**STAFF REPORT
KETCHUM PLANNING AND ZONING COMMISSION
MEETING OF JULY 27, 2021**

PROJECT: Crossbuck West Townhomes

FILE NUMBERS: P21-048 & P21-049

APPLICATION: Design Review and Townhouse Subdivision Preliminary Plat

C2

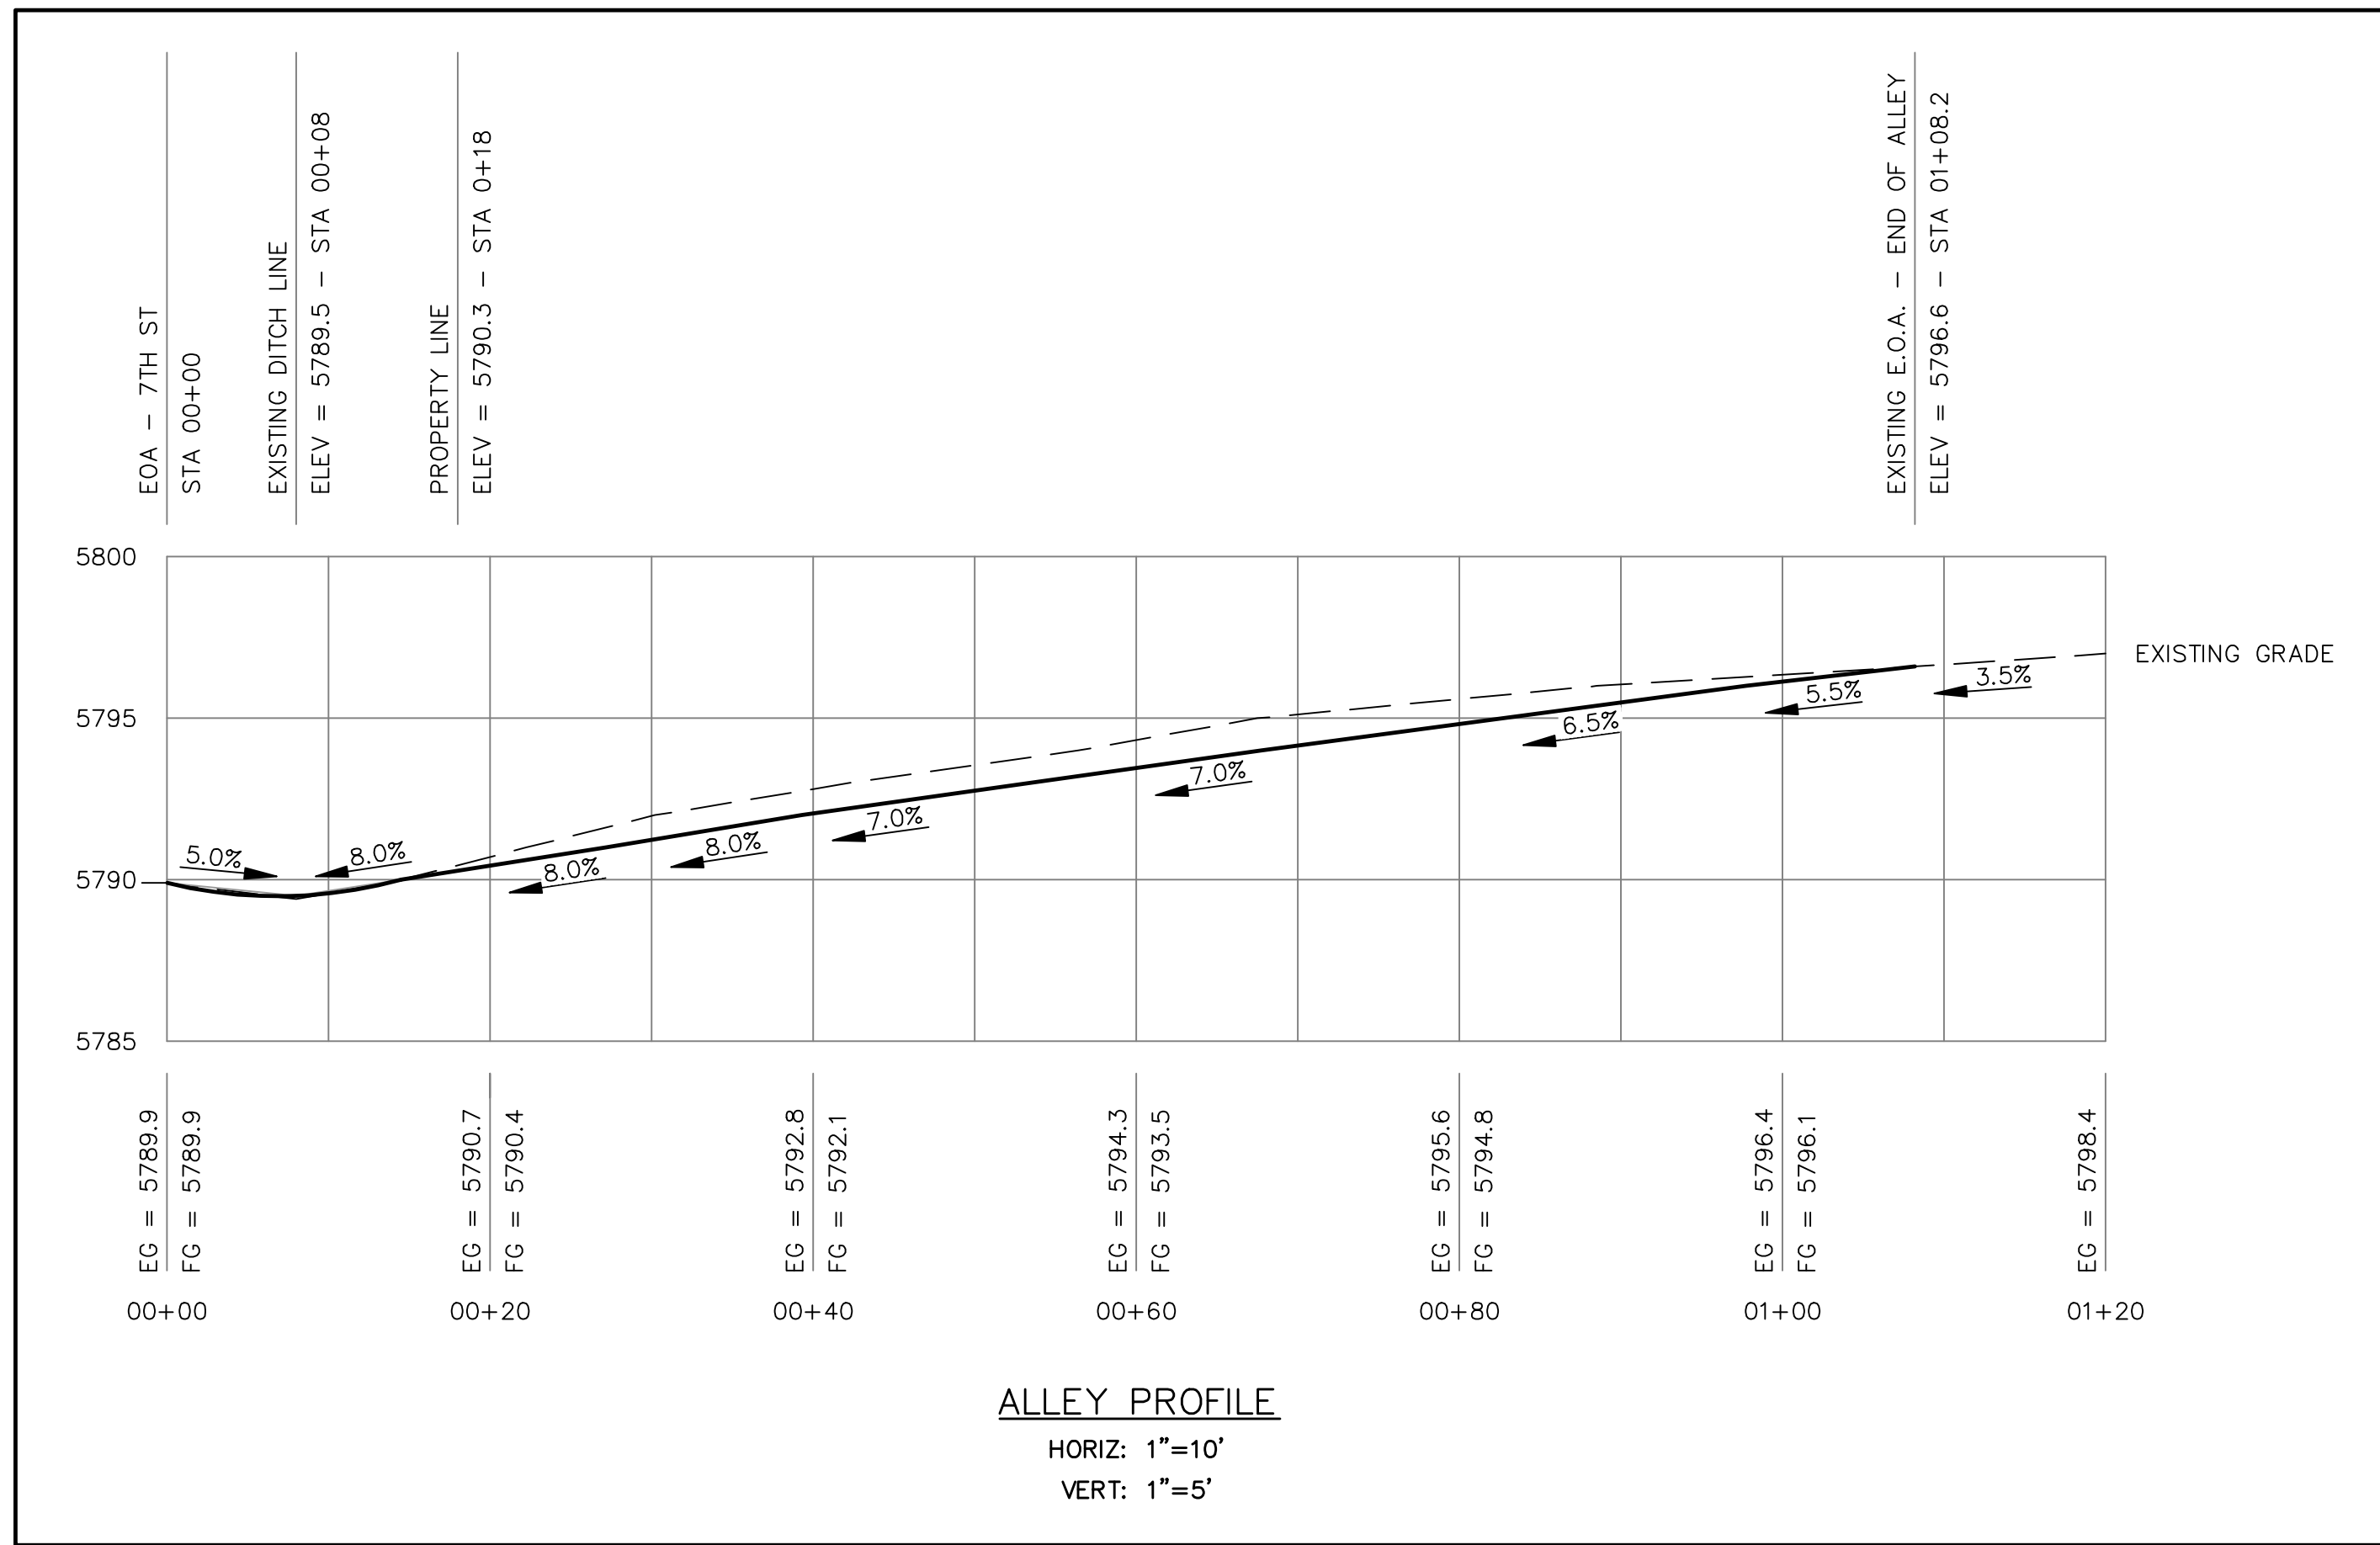
<p>The applicant shall improve the right-of-way (ROW) adjacent to the front property line along 7th Street to City ROW standards for residential roadways. The required right-of-way improvements are indicated on Sheet C2 of the project plans. Material shall be pervious/permeable to allow drainage. Surface must allow for vehicle parking and be consistent along the entire property frontage. Material within the first eight (8) feet from edge of asphalt shall be distinct from driveway and rest of property in order to visually appear to be available for parking. Grading and drainage improvements must meet the following standards: minimum 5% slope, no obstructions, such as boulders or berms, no buried irrigation systems within the first eight (8) from the edge of asphalt, and no subsurface irrigation lines are permitted beyond the first eight (8) feet, however popup heads are not permitted anywhere in the ROW. No live plant material within the first eight (8) feet from edge of asphalt. Low ground cover plant material, such as turf grass, is permitted beyond the first eight (8) feet. Drought-tolerant species is preferred. The applicant shall improve the remainder of the Block 67 alleyway to City standards.</p> <p>Final civil drawings for all associated ROW improvements shall be submitted with the building permit application to be reviewed and approved by the City Engineer and Streets Department prior to issuance of a building permit for the project.</p> <p>See Table 1 for comments and conditions from the City Engineer & Streets Department.</p>

Sheet No:
L3.0

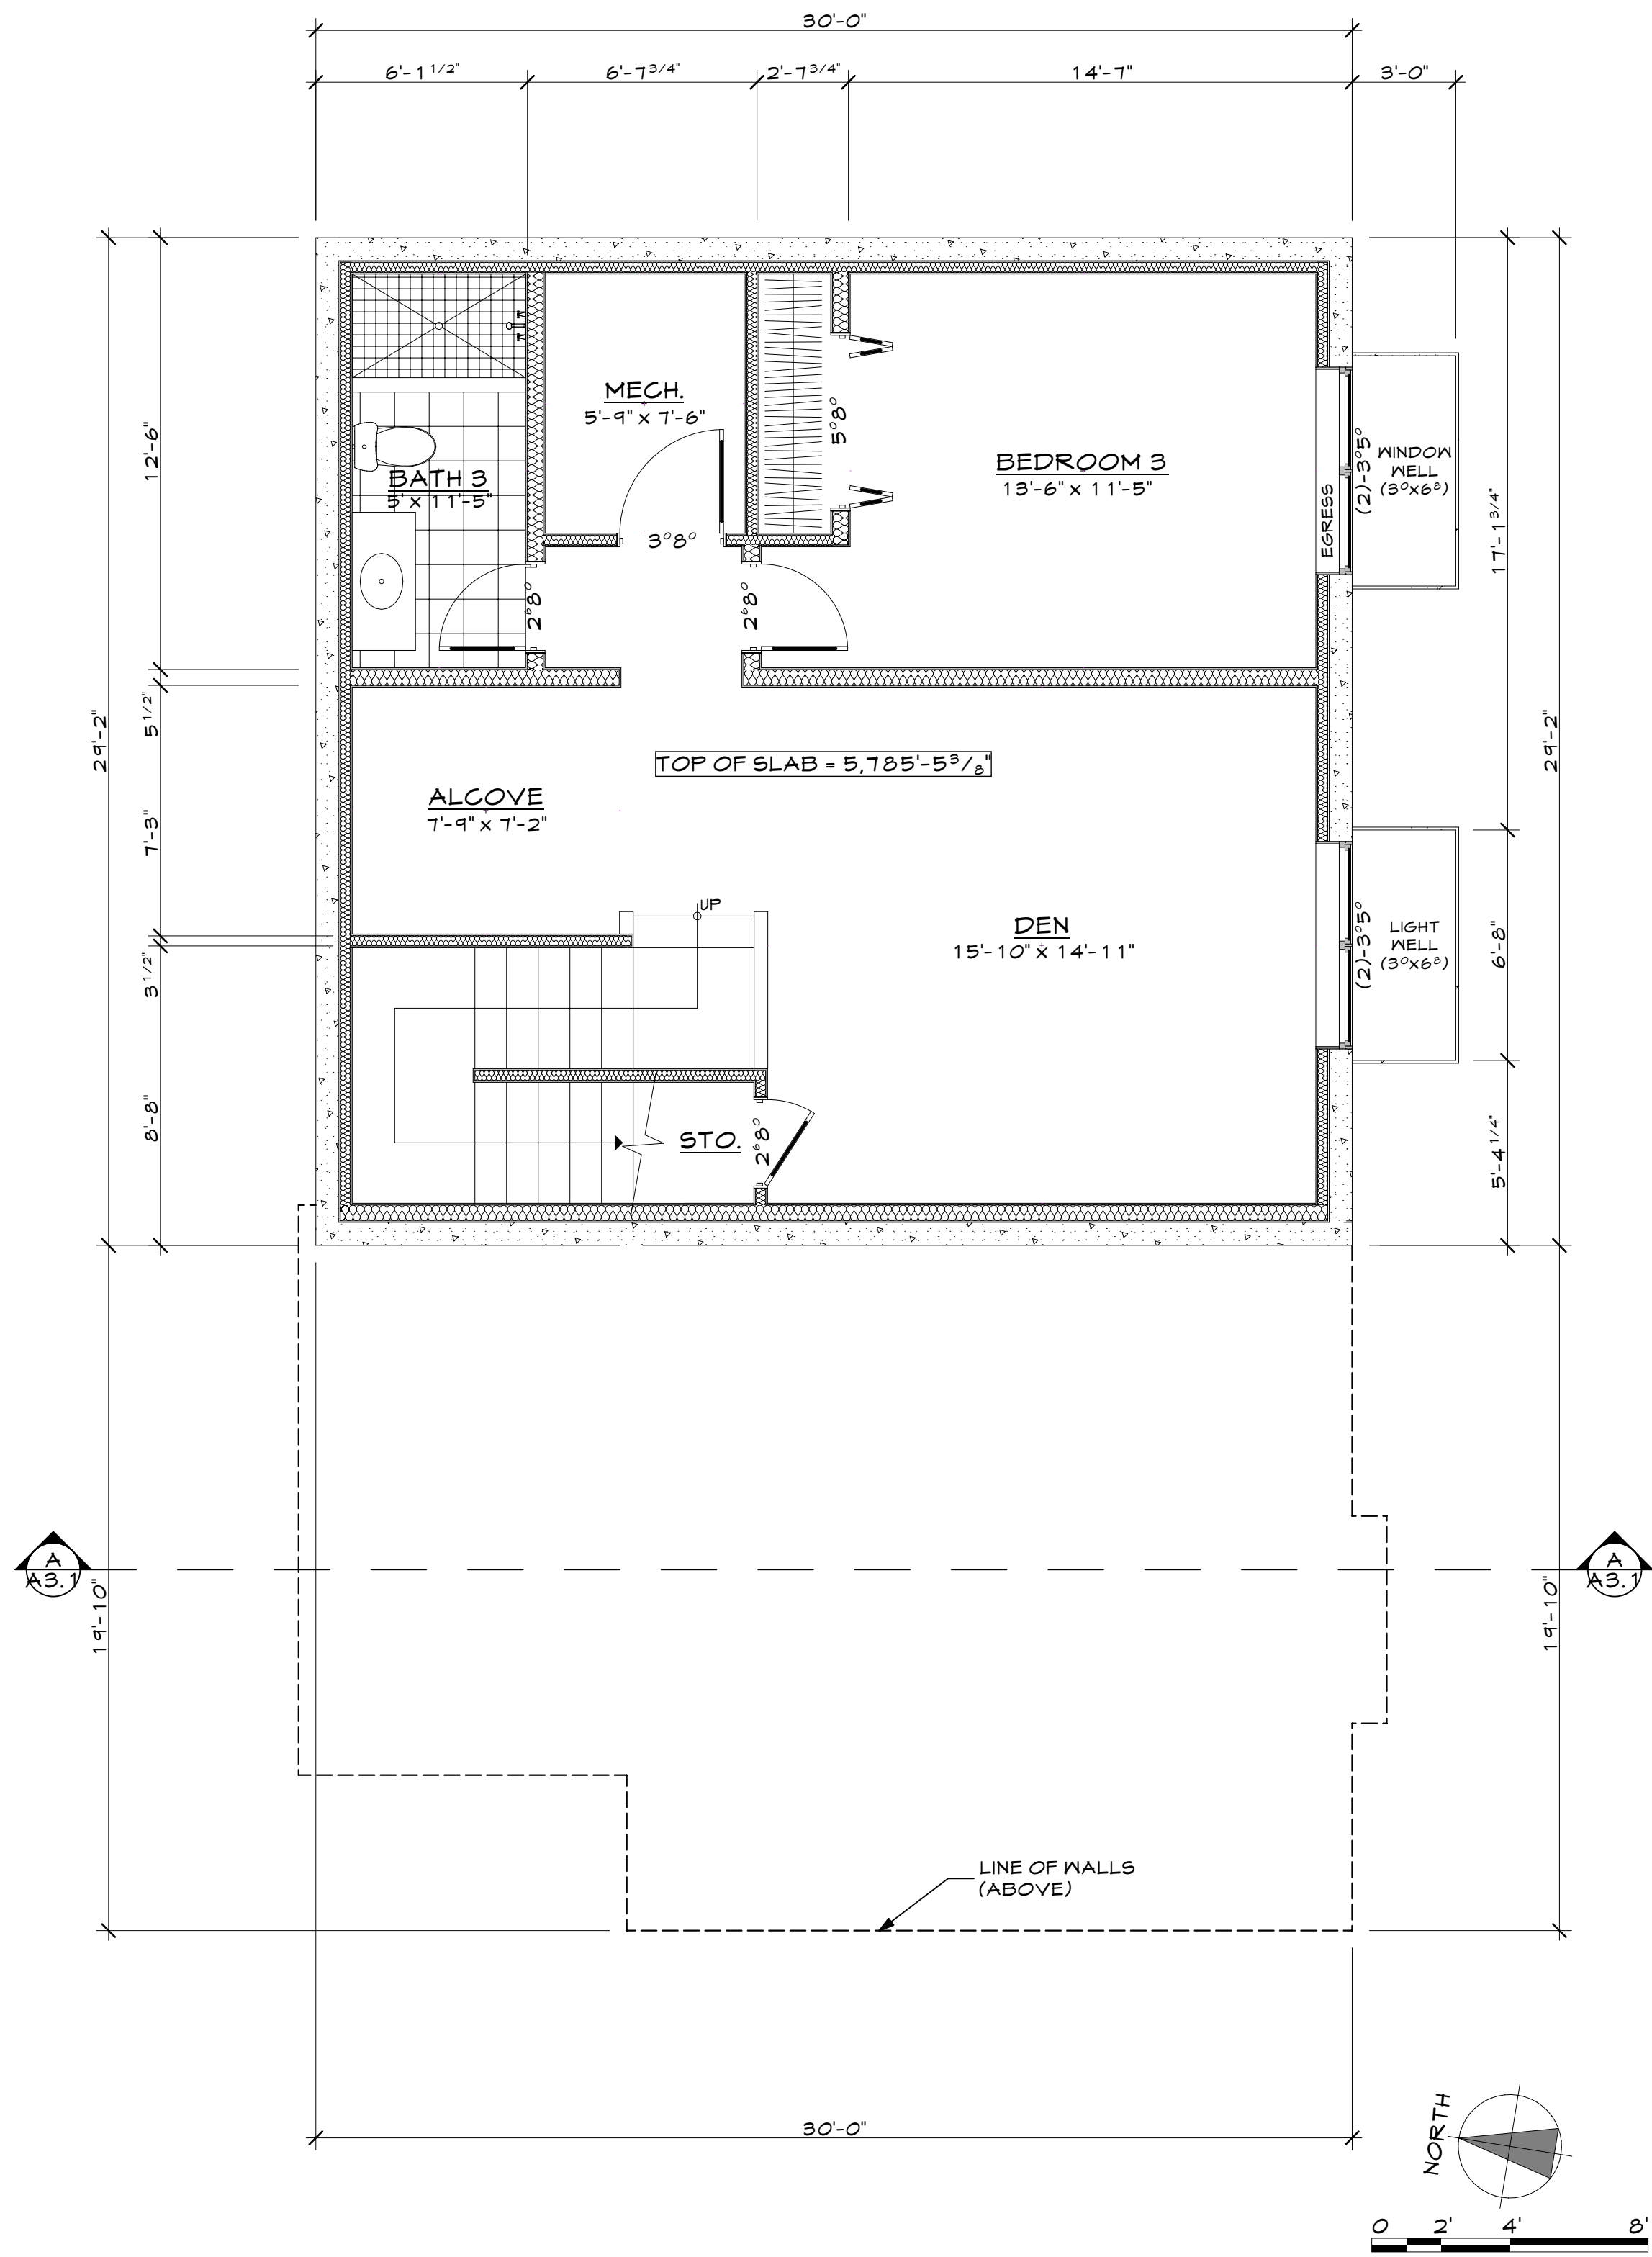
Staff Comments	The applicant will install new landscaping as indicated on Sheet L-3.0 of the project plans.
